RESPONSES TO DNR COMMENTS ON CHAPTER 1 OF THE ENVIRONMENTAL IMPACT REPORT

Exxon Minerals Company Crandon Project

Chapter 1.0

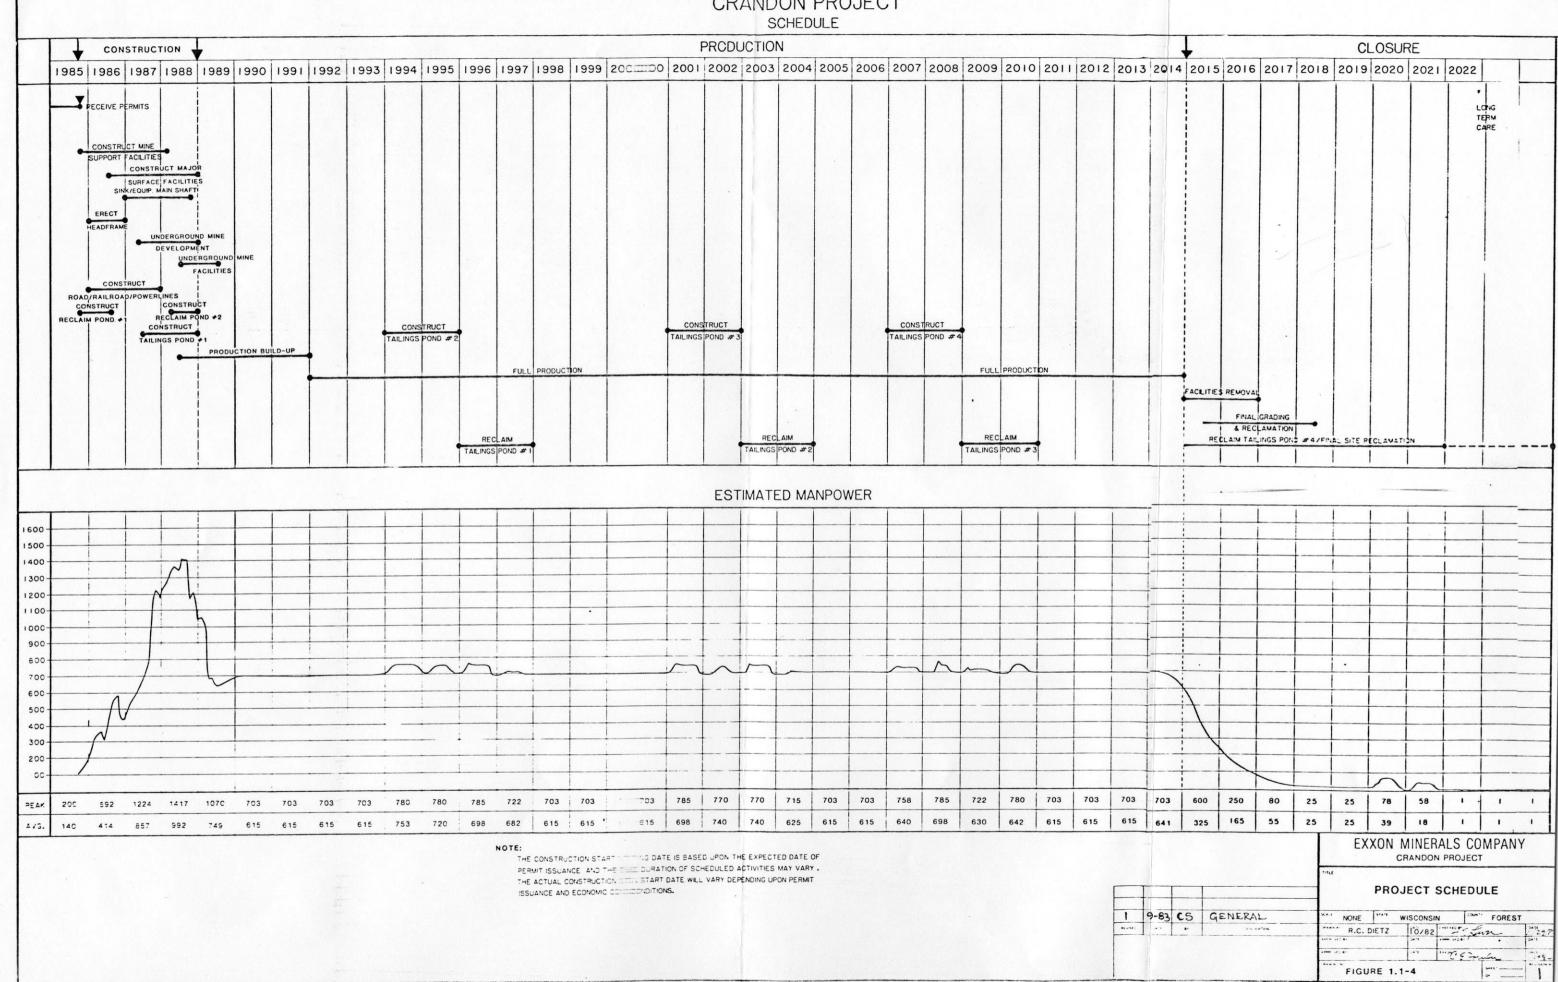
Figure 1.1-4 which indicates projected peak manpower requirements, must be supported by detailed employment needs by job category in Sections 1.3.3.1 and 1.4.2. Manpower requirements must be broken down by year, and must be accompanied by the assumptions and data used to derive the projections.

Exxon's new manpower projections consistent with the current execution philosophy are reflected in the attached Project schedule. Response to comments No. 30, 31, and 154 are based upon these new projections shown in Figures 1.1-4, Revision 1 (attached) and figures accompanying response to comment No. 154. The new information reflects current planning; however, it is subject to changes in their inherent dependency on market conditions, permitting factors, and Exxon's corporate decision process.

A condensed schedule for the Crandon Project is presented in Figure 1.1-4, Revision 1. This schedule illustrates schedule durations and interrelationships of major activities. The estimated manpower requirements required for each Project phase are presented, with further detail of employment needs given in subsections 1.3.3.1 and 1.4.2. Please refer to the response to comment No. 154 for these figures, the detailed manpower projections and the basis for development of these figures.

PERMITS REQUIRED TO BEGIN CONSTRUCTION OF THE CRANDON PROJECT

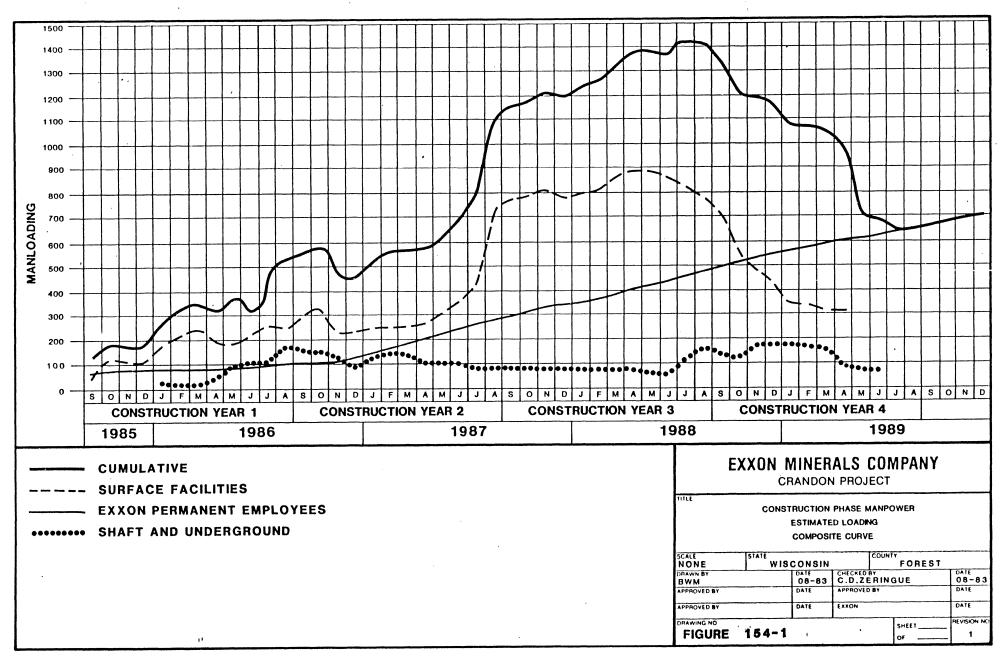
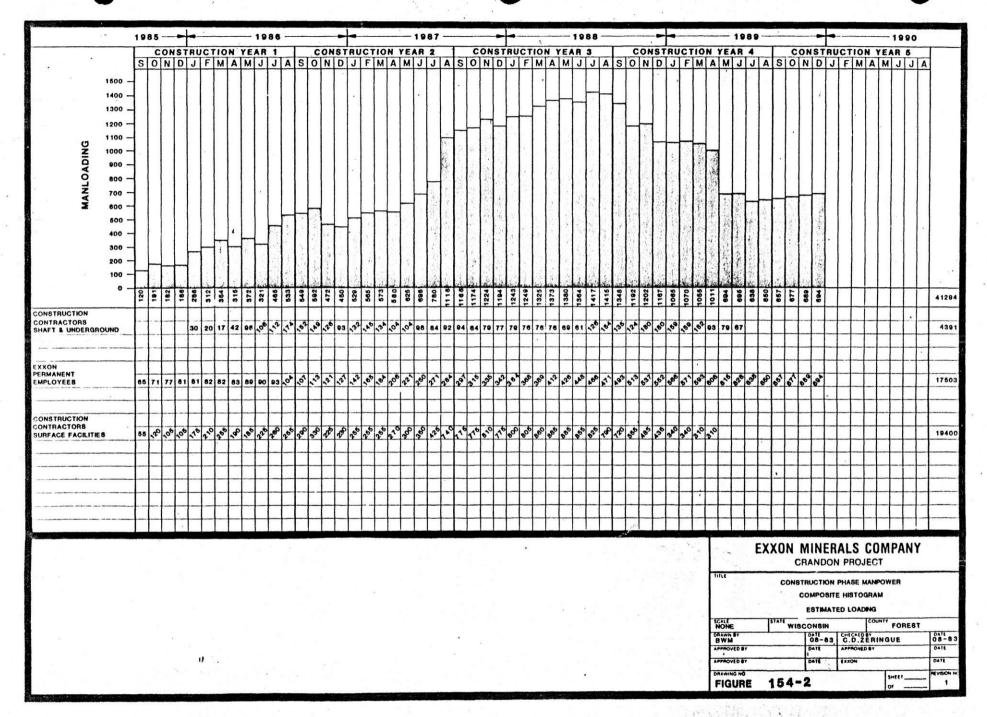
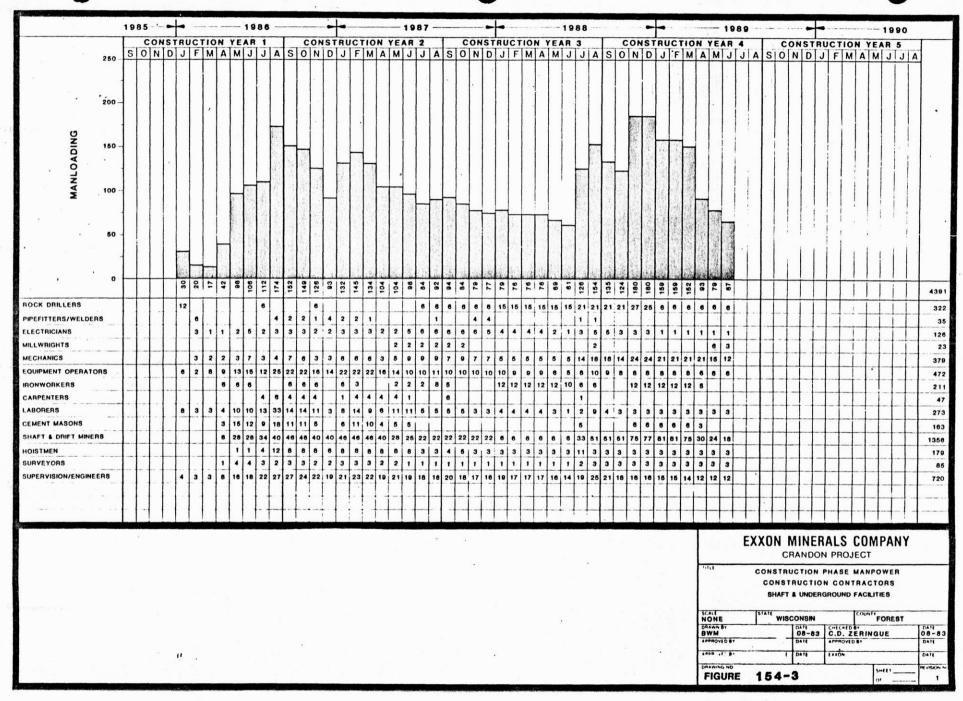
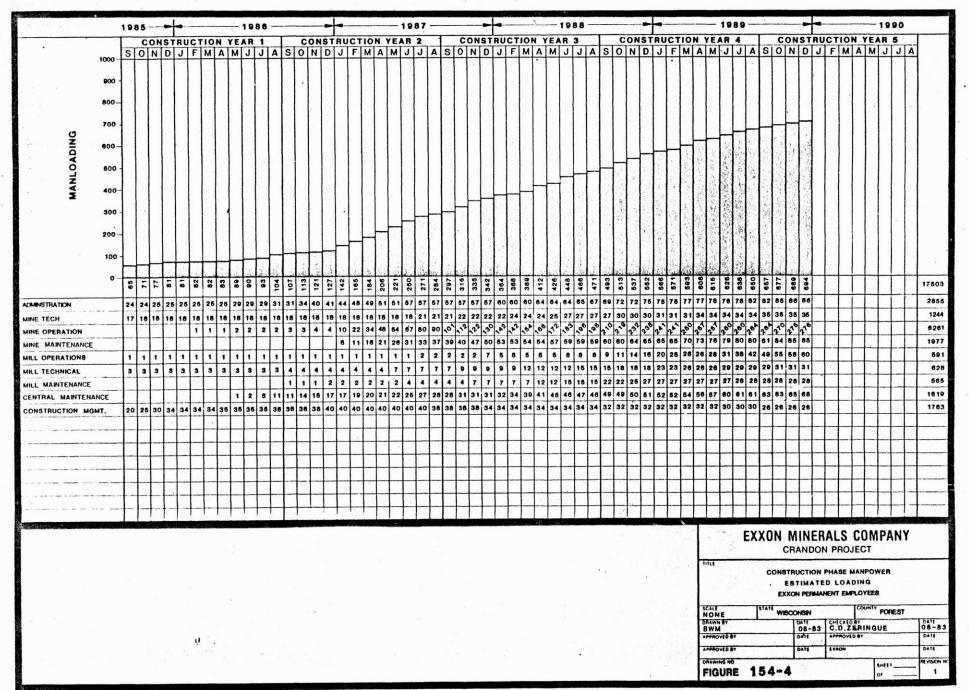
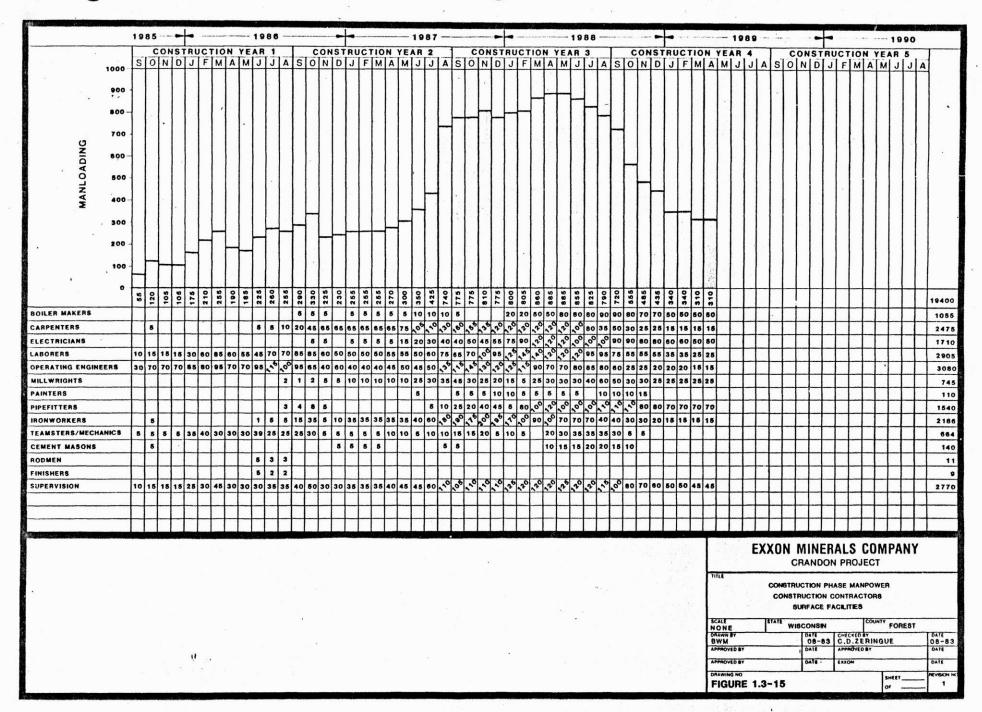
As previously indicated, projected manpower requirements must be accompanied by detailed employment needs by job category over the construction period. The data and assumptions used as a basis for Figure 1.3-15 are needed.

A composite curve illustrating total manpower requirements during construction and into the production phase is given in Figure 154-1 (attached). This curve depicts manpower requirements for three major areas: shaft and underground facilities, Exxon permanent employees, and surface facilities. Figure 154-2 (attached) presents the total manpower requirements for each area by month. Assumptions used for the development of each major area follows:

- 1) Contractor Construction Manpower the detailed construction manpower requirements by craft for the shaft and underground facilities are shown on Figure 154-3 (attached). Activities include sinking the main and ventilation shafts, headframe erection, development of the rail haulage drift, and development of the underground crushing station including equipment installation. Manpower assessments were developed for each activity based upon contractor estimates for construction of the headframe, main shaft sinking, and intake air shaft sinking. These estimates evaluate crew sizes based upon shift requirements and schedule demands. The remainder of the activities are developed similarly through analysis of each construction task, determination of required equipment and materials, and development of crews for each task.

- 2) Exxon Permanent Employees (see Figure 154-4 [attached]). Exxon permanent employees who will be involved in operations, maintenance, and technical support for the mine and mill facilities are included in Figure 154-4. These personnel will be engaged in underground mine development work and prestart-up of the surface production facilities. They will also fulfill construction management requirements for administration of various contracts for surface and underground work prior to mine and mill start-up. During start-up many of these people will assume their permanent positions as operations, maintenance, and technical support staff. Positions were first identified on an overall Crandon Project organization chart. All positions were then staged through the construction phase, and into the production phase, to meet schedule demands for mine/mill start-up, construction management requirements, and reasonable rates for effective employee assimilation and training.

- 3. Contractor Construction Manpower Surface Facilities (see Figure 1.3-15 Revised [attached]). Contractor manpower will be engaged in the construction of the railroad, access roads, tailing pond Tl, reclaim ponds Rl and R2, and all other surface facilities. These include coarse ore storage, fine ore crushing, concentrator building and all facilities therein, services building, water treatment plant, plant water systems,
